Technical Bulletin

Model
928, 928S

Subject: Modified Lower Ball Joint Support and Mounting

Number
84-01

Fig. 1 New version

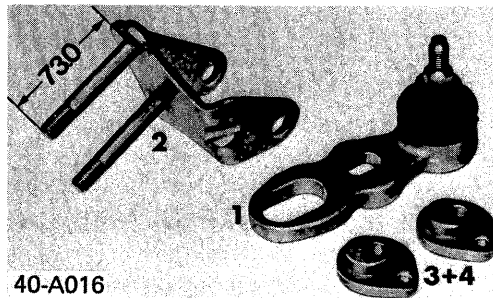
From September, 1983; VIN 92 ES 860404, lower ball joint support and mounting hardware is changed as follows:

- steel ball joint support instead of aluminum
- shorter studs in mounting brackets
- identical caster/camber adjusting eccentrics

Caster/camber holes in ball joint support have been switched. Caster is now adjusted with the inner eccentric and camber with the outer.

Fig. 2 Caster/camber adjusting eccentrics, new version

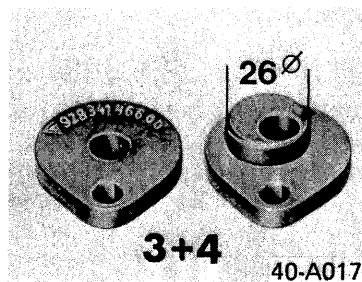
- New version eccentrics are identical and are stamped with the new part number

Fig. 3 Previous version

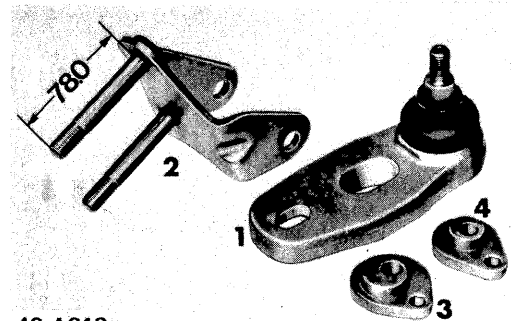
New and old version component pieces may **not** be interchanged.

New version parts may be installed on one or both sides of an earlier vehicle, but initial installation requires use of following parts (see Fig. 1 and 2):
